Addendum No.: 3

Date Of Addendum: 5/21/2019

Rooftop A/C & Roof Replacement
300 Corporate Place
Rocky Hill, CT
BI – 2B – 387

ADDENDUM #3
**ROOF TOP A/C UNIT AND
 ROOF REPLACEMENT**
 300 CORPORATE PLACE, ROCKY HILL, CT
 Project No. BI-2B-387

MAY 17, 2019
SKP-03
 DRAWING REF: P-103

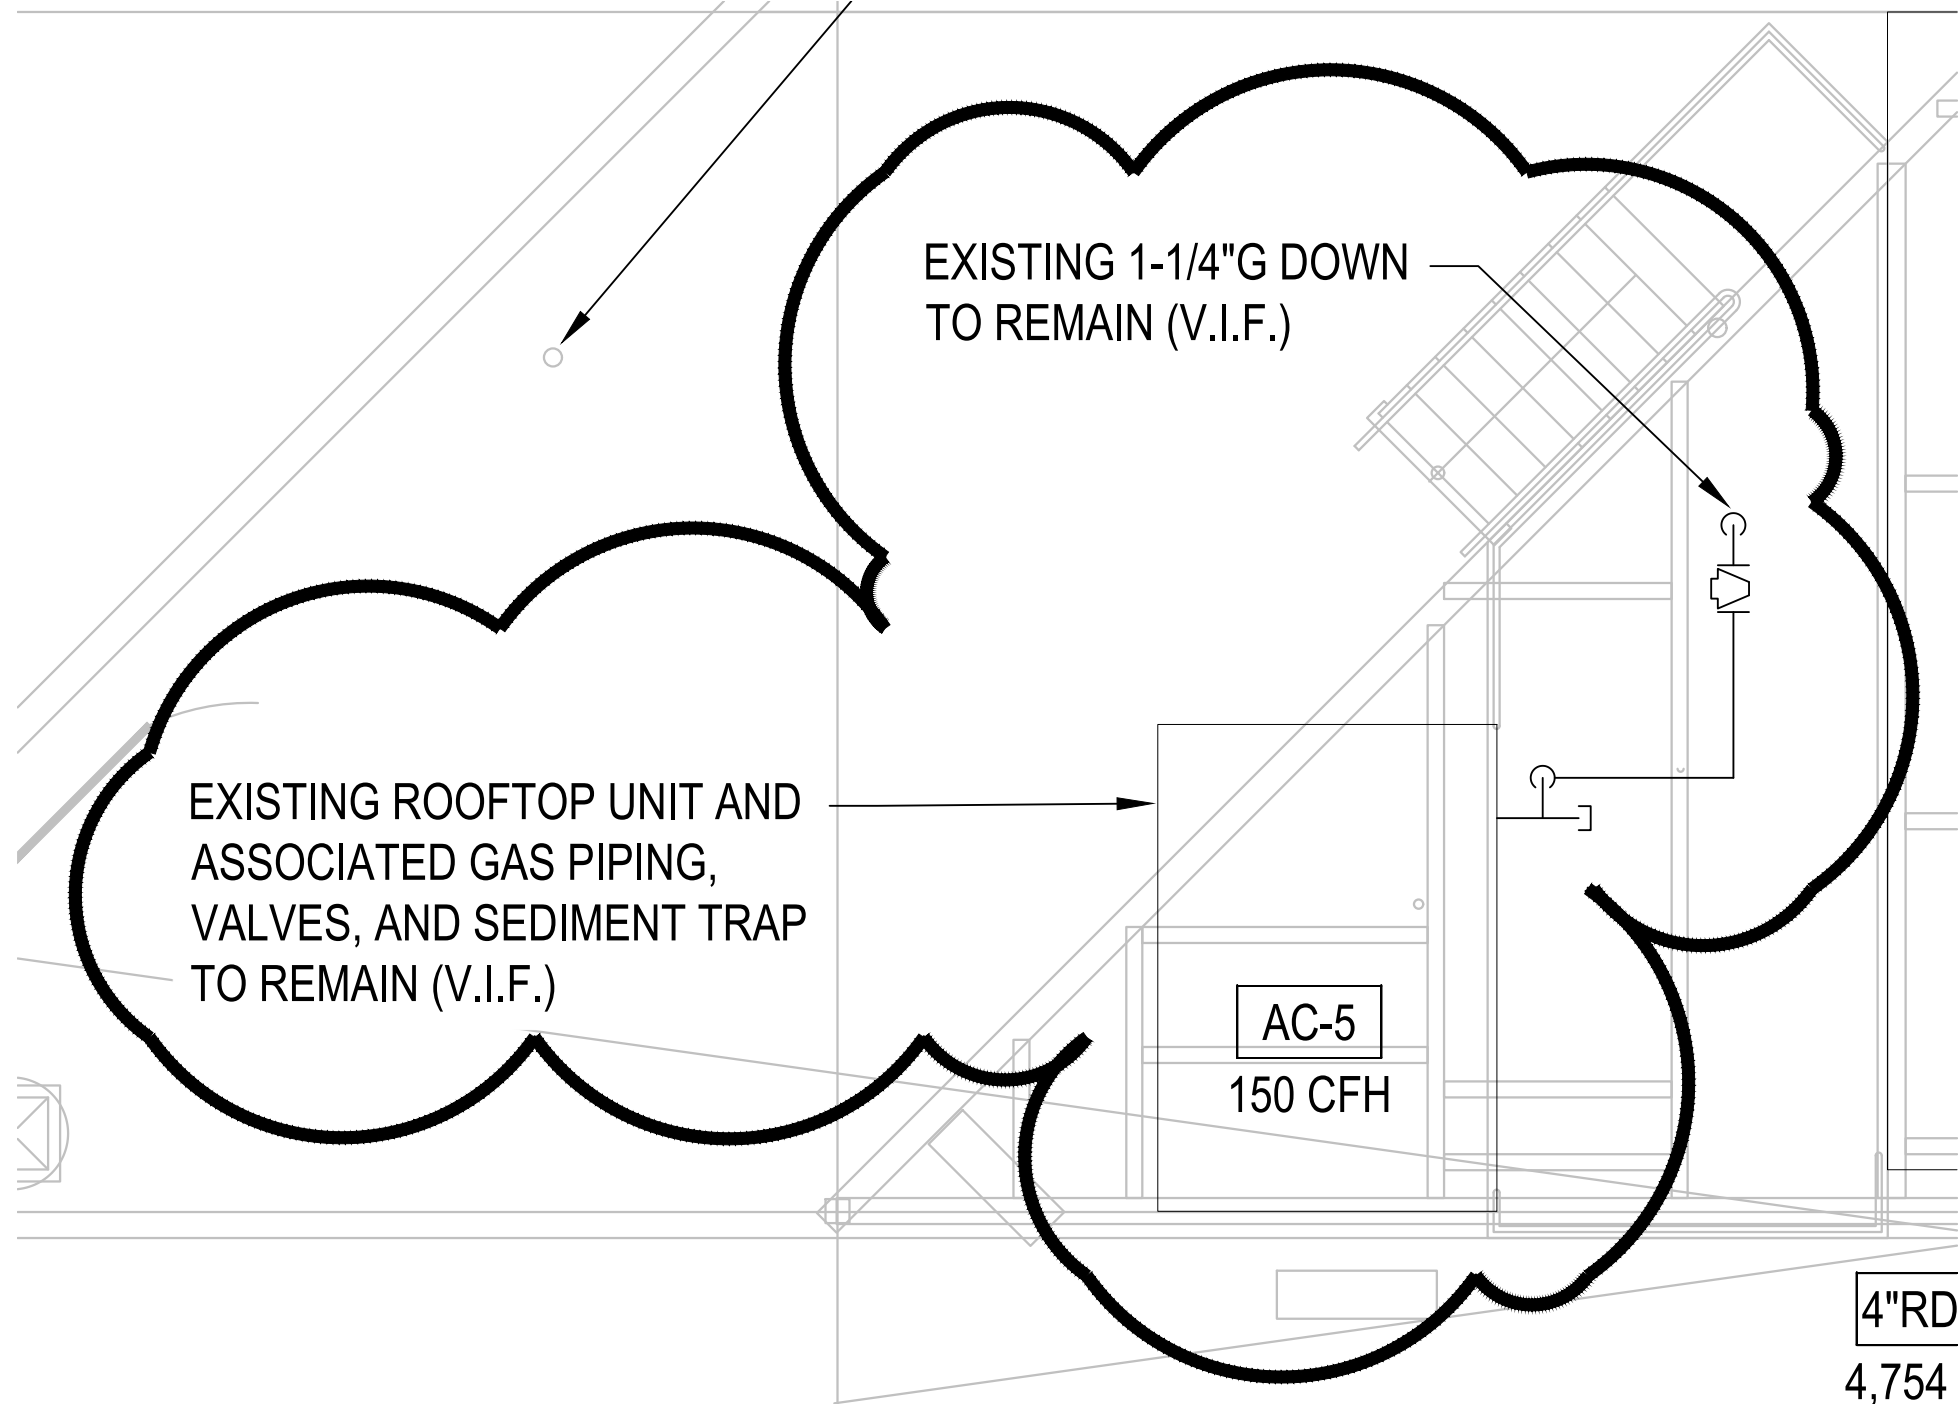
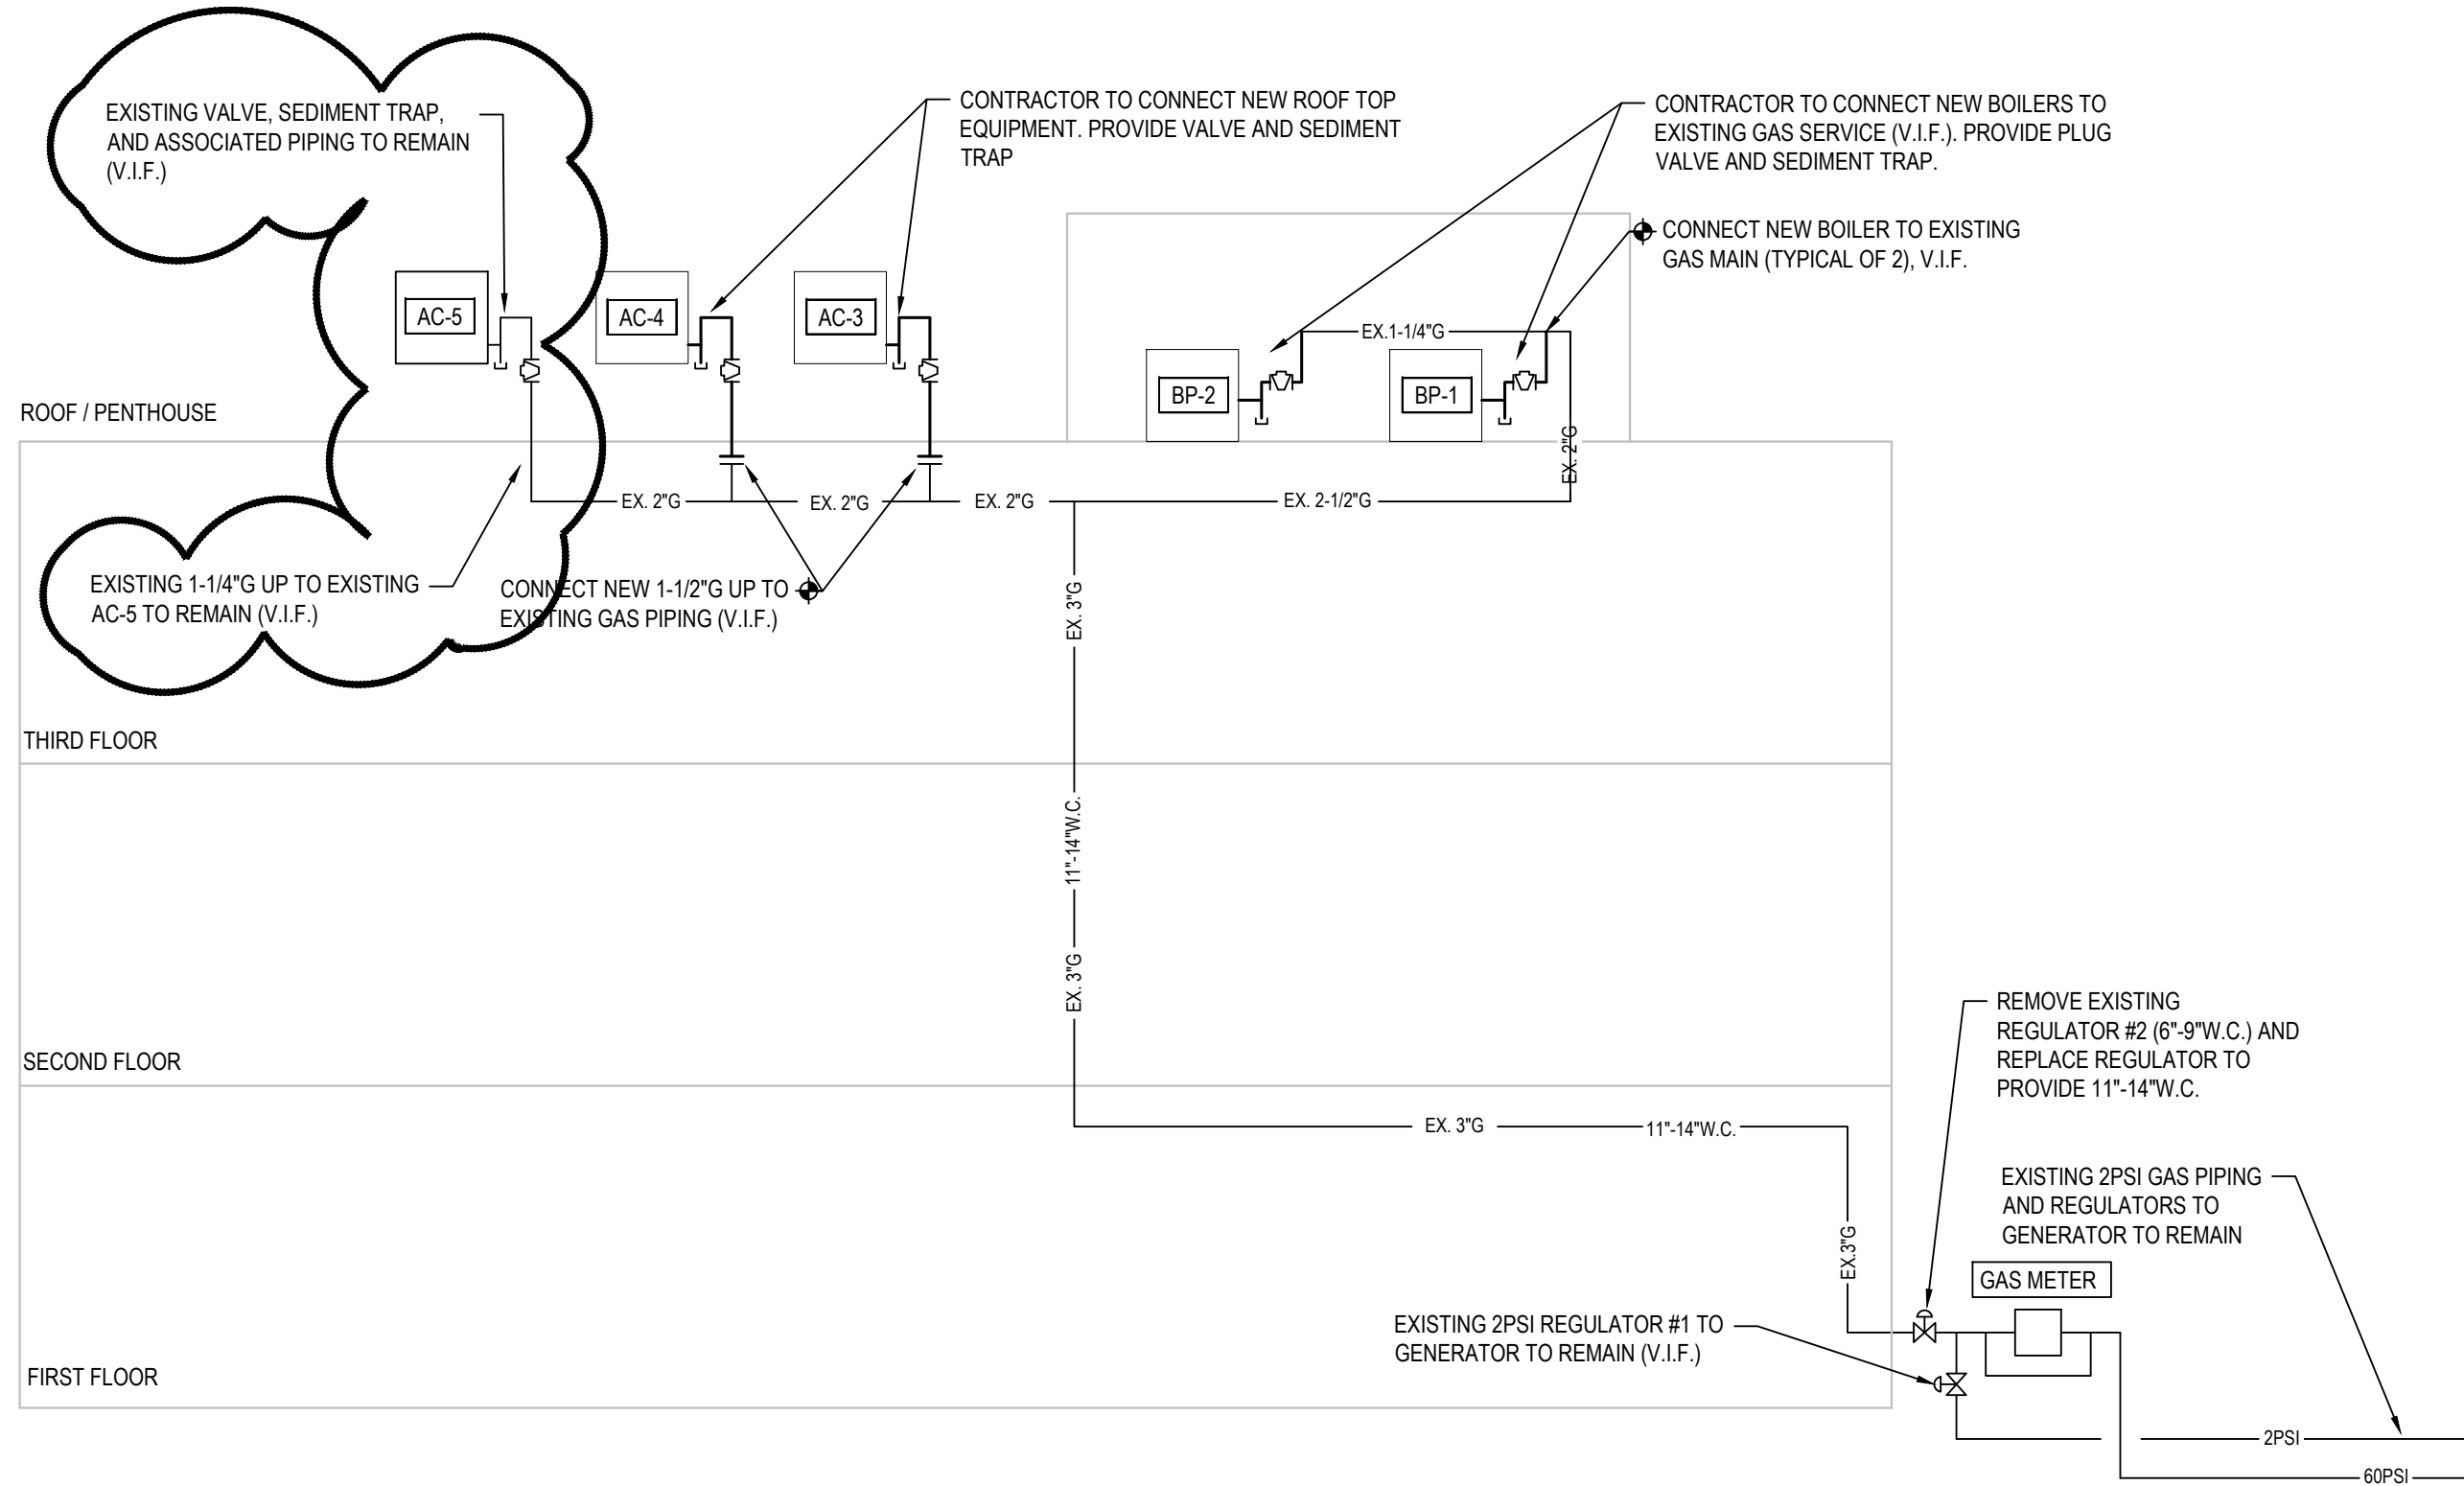
Contract Drawings MD-104, M-101, M-104, ED-104, E-104, E-401, PD-103, PD-104, P-103, P-104, P-204
Revise Contract Drawings with attached sketches SKM-02, SKM-03, SKM-04, SKE-03, SKE-04, SKE-05, SKP-01, SKP-02, SKP-03, SKP-04, SKP-05 and SKP-06 for removal of all work associated with rooftop unit AC-5.
AC-5 is being replaced under BI-2B-452 – Coordination between project BI-2B-387 and BI-2B-452 may be required.

SKP-06

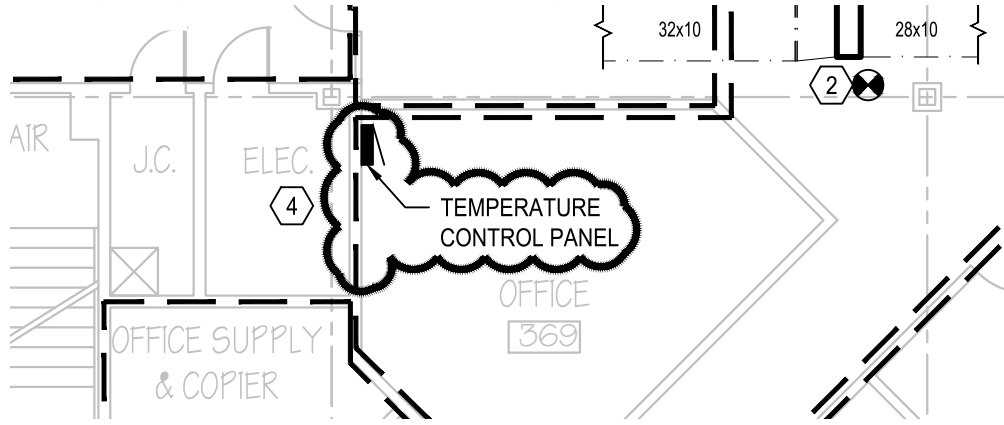
GENERATOR (EXISTING TO REMAIN) =	1,373 CFH
BOILER #1=	375 CFH
BOILER #2=	375 CFH
BOILER #3=	375 CFH
BOILER #4=	375 CFH
AC-3=	500 CFH
AC-4=	500 CFH
AC-5 (EXISTING TO REMAIN) =	150 CFH

GENERATOR (EXISTING)=	1,373 CFH
BOILER #1 =	750 CFH
BOILER #2 =	750 CFH
AC-3 =	500 CFH
AC-4=	500 CFH
AC-5 (EXISTING) =	150 CFH
